LAND NORTH OF ARBORFIELD ROAD, SHINFIELD
DESIGNER'S RESPONSE

BELLWAY HOMES LTD (THAMES VALLEY)
05 February 2026

Prepared by:	E Hine
Authorised by:	A Golding
Date:	05 February 2026
Document Reference:	HD008-R005/A

Stage:	2
Location:	Land North of Arborfield Road, Shinfield, Berkshire
Site:	Proposed residential development and right-turn lane access
ATSS Ref:	251206
Client Ref:	HD008
Date:	28 January 2026

Appendix B: Key Plan showing Audit Problems

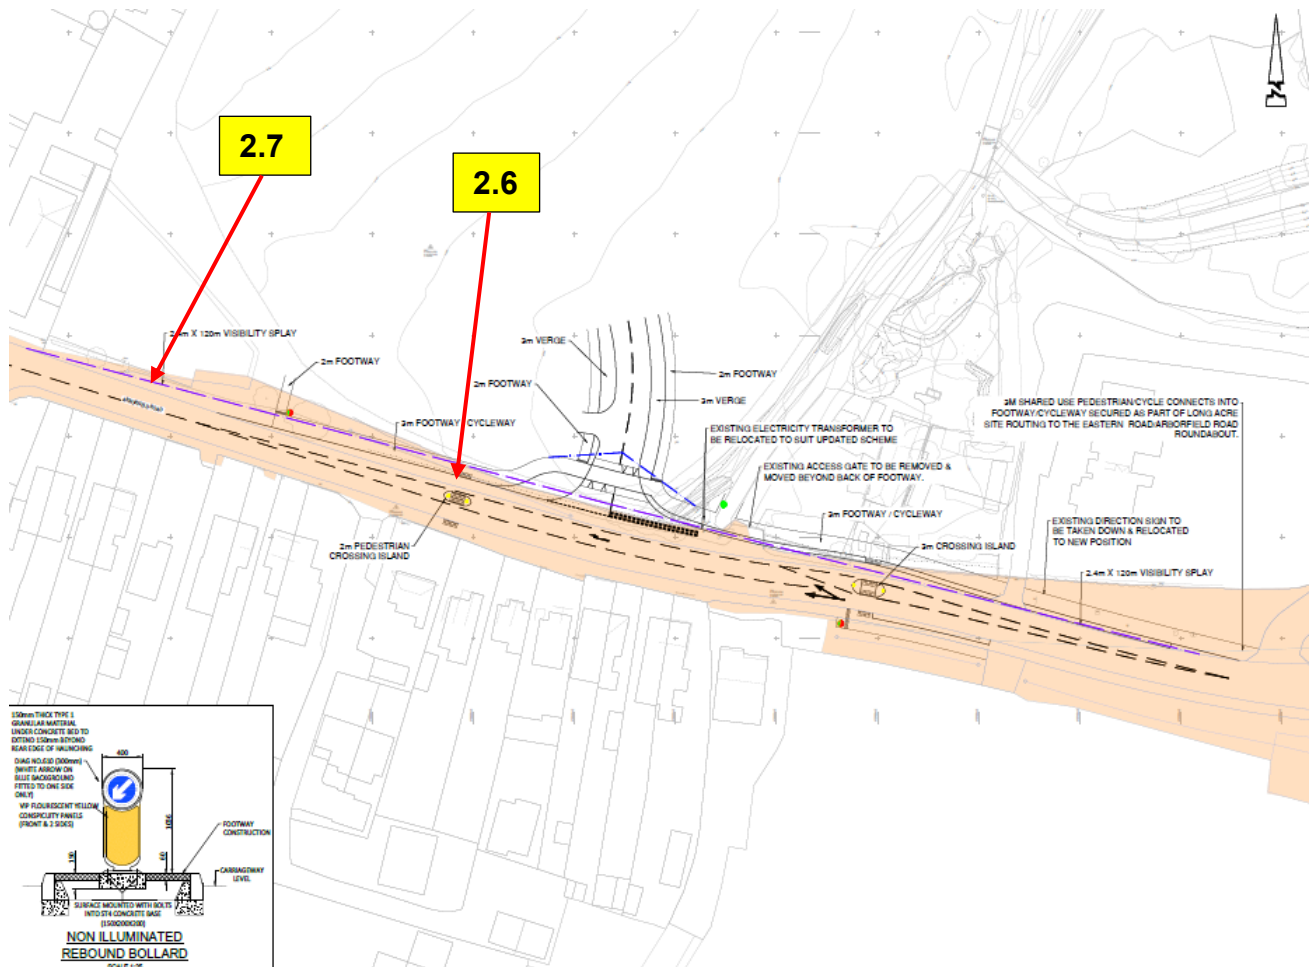
Location – Proposed road connection to Shepherd Road, north end of site

Summary – Risk of pedestrian falls

The proposed road crosses a ditch. Pedestrians using the footways either side risk falling into the ditch and injuring themselves on hard-edged headwalls etc

Recommendation – Assess the risk of falling into the ditch, and provide fencing if considered necessary

Location – Shared use path to east of site

Summary – Risk of cycle/pedestrian collisions, and falls into attenuation pond

The shared use path passes close to the attenuation pond at the south east corner of the site. There is a risk that users may fall into the attenuation pond. Appropriate signage will also be necessary to appraise users of the shared use status of the path

Recommendation – Assess the risk of falling, and provide fencing if considered necessary. Provide appropriate shared use signage

Location – Parking bays opposite plots 82-84

No hardstanding has been provided adjacent to these parking bays. Vehicle passengers exiting on the verge side risk slipping on grass in wet or icy weather

Recommendation – Provide hardstanding next to parking bays

Location – Path from play park opposite plot 122

This path does not connect with the shared use carriageway outside plot 125. Pedestrians will need to cross a small area of verge where they will risk slipping on grass in wet or icy weather

Recommendation – Extend the path to reach the shared use carriageway

Location – On-road parking bays (3 locations)

These parking bays appear to be very close to walls, such that opening a door on one side may be difficult without striking the wall, and entering/leaving the vehicle may also be difficult

Recommendation – Ensure there is enough room to open doors and enter/leave vehicles safely

Location – Shared use path along eastern side of development

Several of the side roads are connected to the shared-use path by footpaths, however there is no corduroy tactile paving indicated where the paths meet, to inform pedestrians that they are entering a shared-use environment

Recommendation – Provide corduroy tactile paving and appropriate signage where footpaths meet the shared-use path

- 2.1.4 *Agreed - Protective fencing will be considered and included if appropriate as the detailed design of the scheme proceeds.*

- 2.2.4 *Agreed - Protective fencing will be considered and included if appropriate as the detailed design of the scheme proceeds.*

- 2.3.4 *Parking bays are oversized at 3.0m wide which is enough to accommodate a parked car and allow for a vehicle's passengers to exit within the hardstanding of the proposed parking bays.*

- 2.4.4 *Agreed – connection to be considered and included as the detailed design of the scheme proceeds.*

- 2.5.4 *At two of the locations the parking bays are oversized at 3.0m wide which is enough to accommodate a parked car and allow for a vehicles passengers to exit within the hardstanding of the proposed parking bay. Similarly, at the third location although the bay is 2.5m wide, the plot boundary fence is located an additional 0.5m away, allowing room to open a car door without striking the wall.*

- 2.8.5 *Agreed - corduroy tactile paving and appropriate signage where footpaths meet the shared-use path will be provided as detailed design of the scheme progresses.*

Drawing No	Revision
HD008-021	A

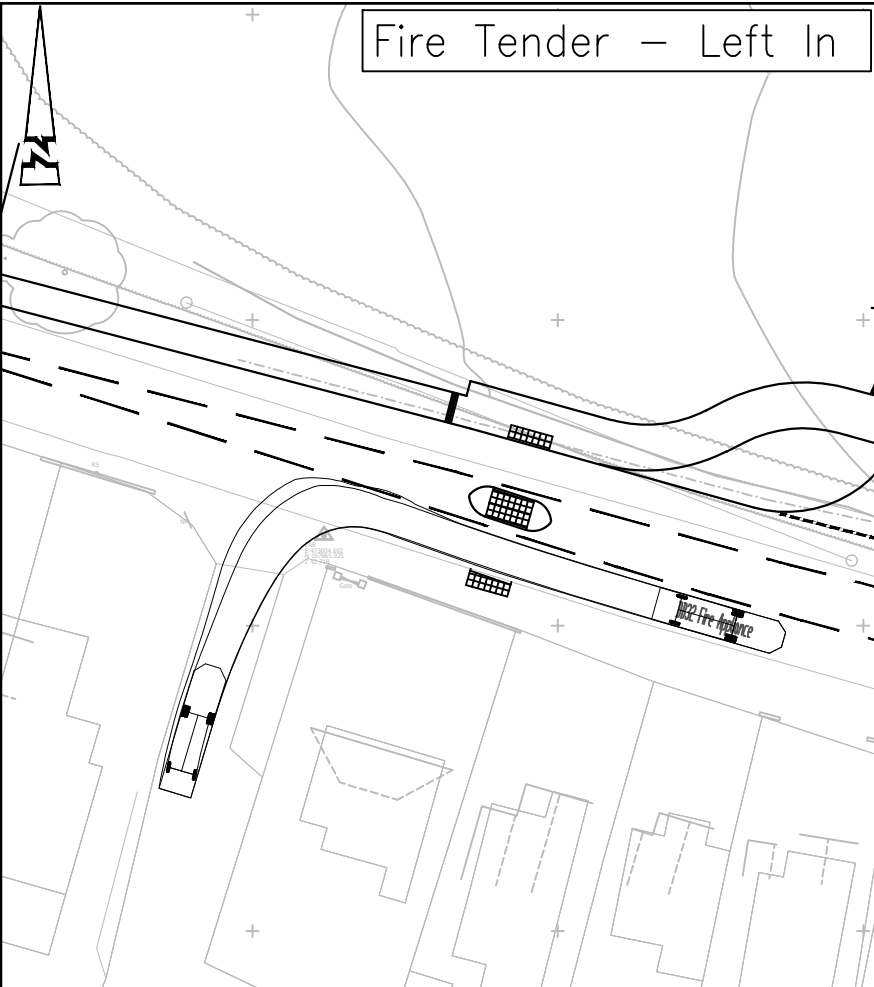
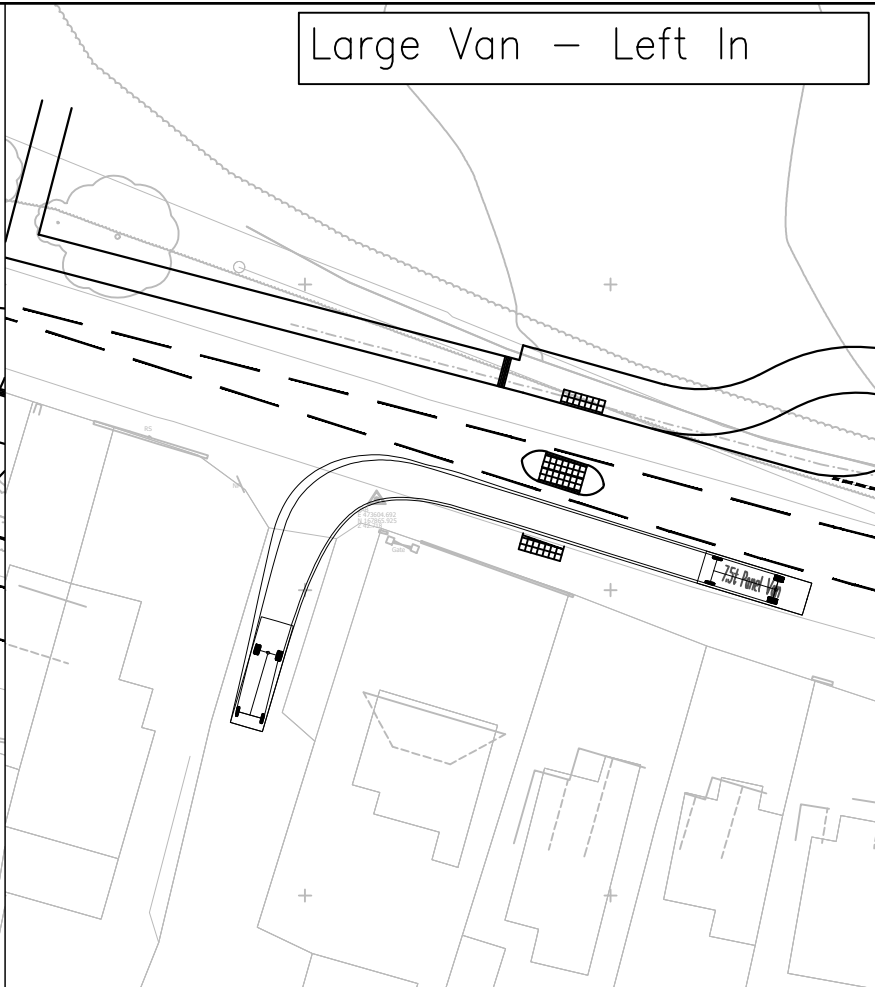
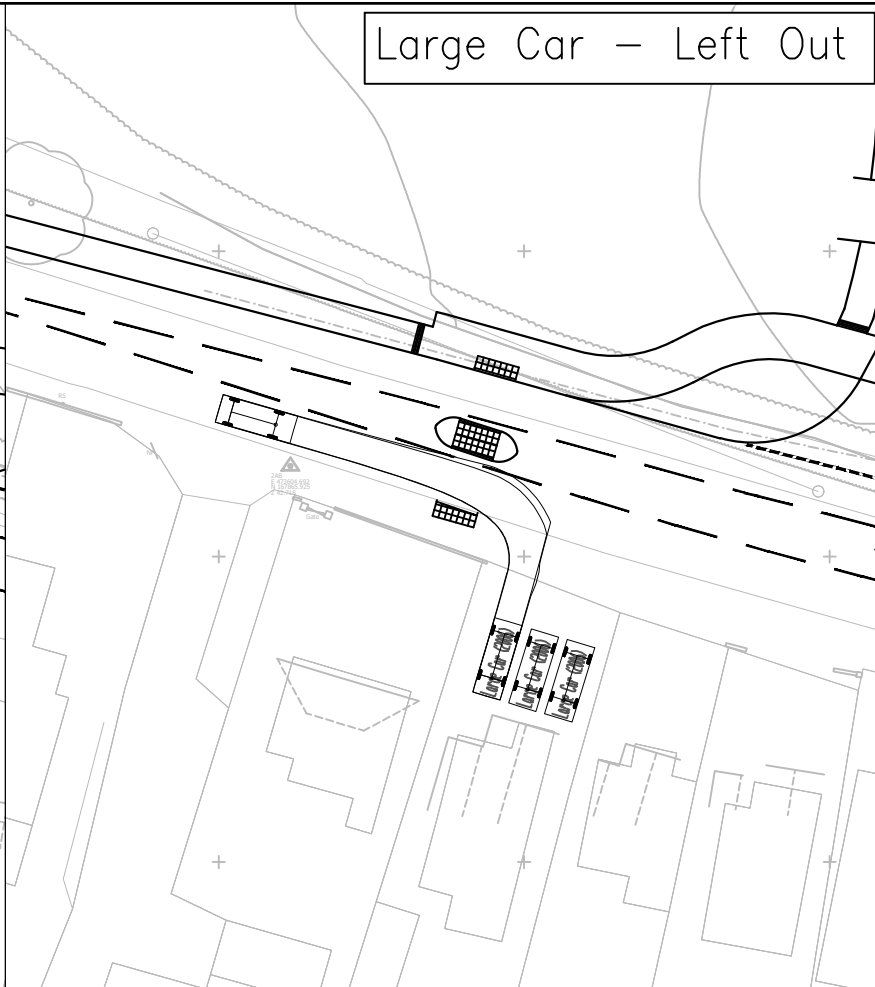
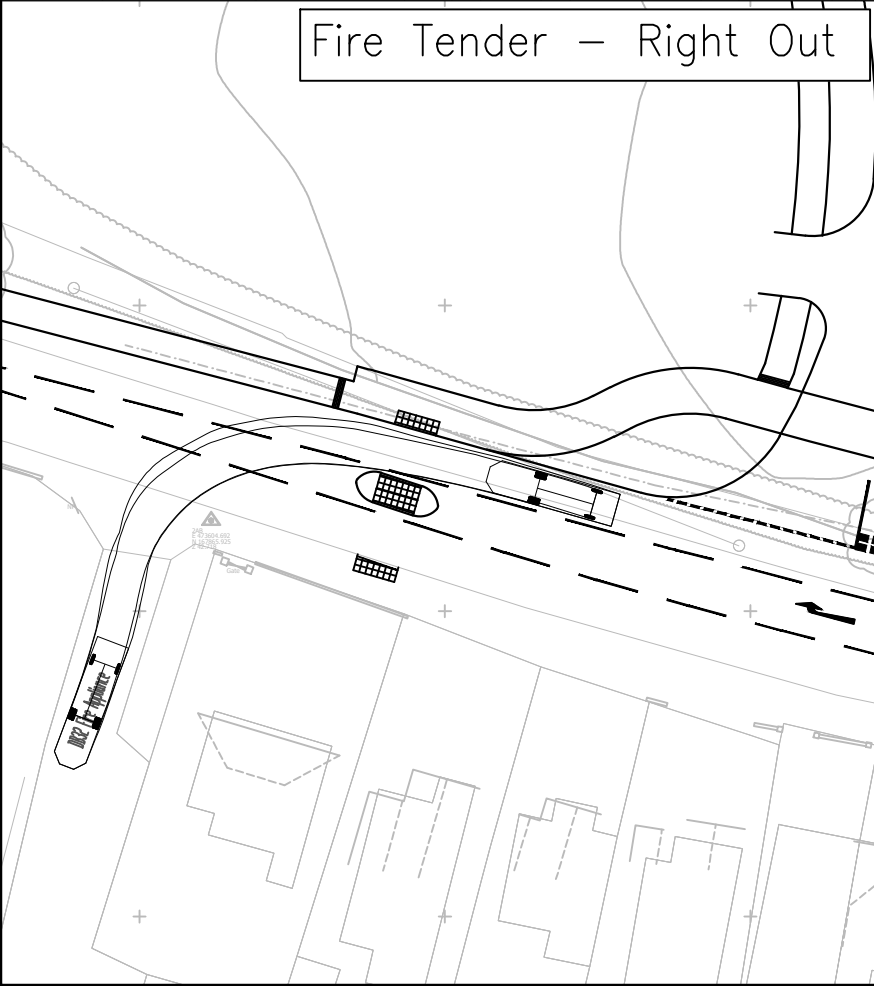
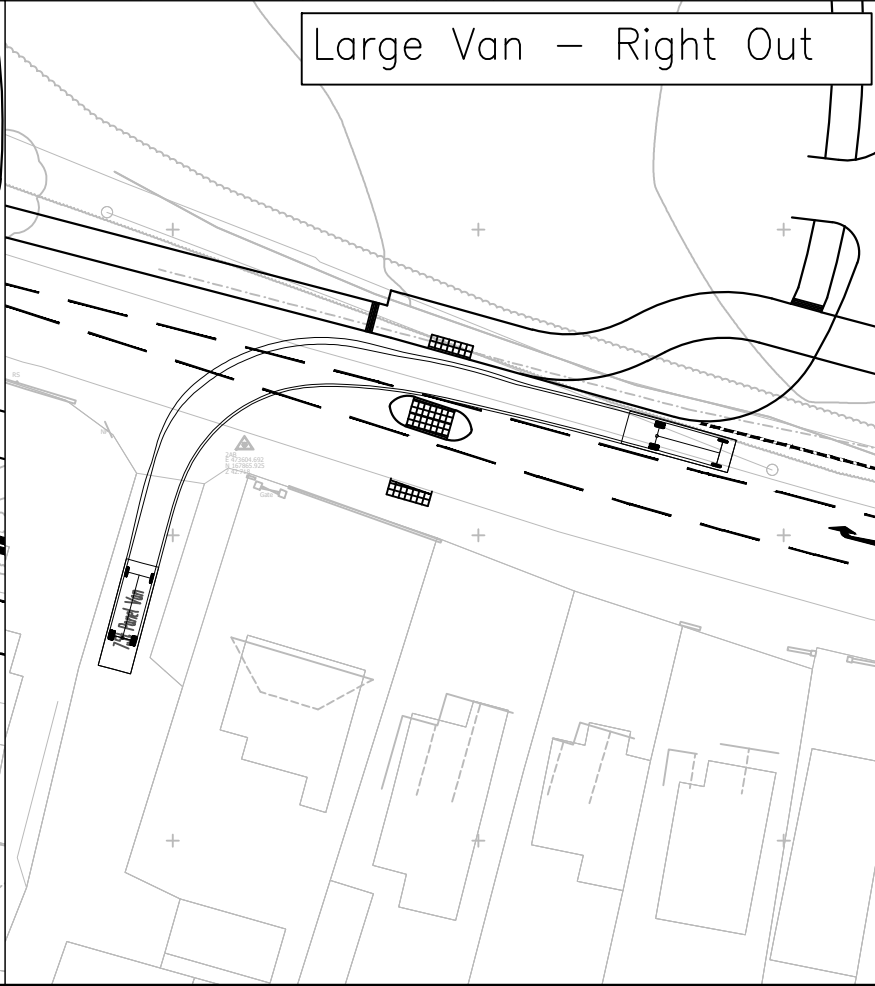
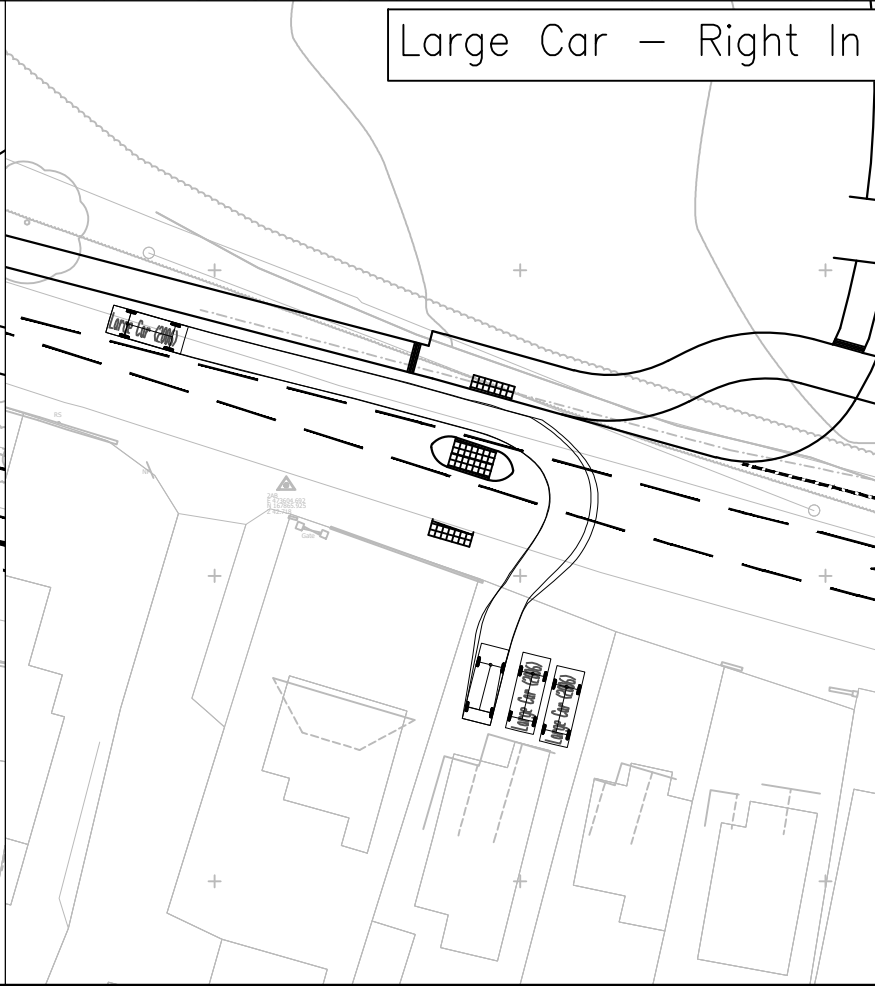
Location – Western proposed central refuge island on Arborfield Road

The island is located between private driveways to the east, and an access road leading to several properties, to the west. No swept path analysis drawings have been supplied for vehicles accessing/exiting the driveways or access road. Access for larger vehicles such as a refuse collection vehicle or removals vehicles may be required for the access road, therefore provision for these vehicles to turn should be maintained (note the island appears to have been relocated slightly to the east as part of the redesign, however it still requires checking)

Recommendation – Ensure all turning movements are possible from/to the driveways and access road. Leave a gap in the hatching where vehicles turn into and out of the access road

- 2.6.4 Agree - Swept path analysis has been undertaken for each of the adjacent private drives, as provided at drawing HD008-021-P1 provided at **Appendix B** to confirm that the required turning movements can be undertaken by arriving or departing vehicles. The road markings will be considered and amended as part of the S278 works process.
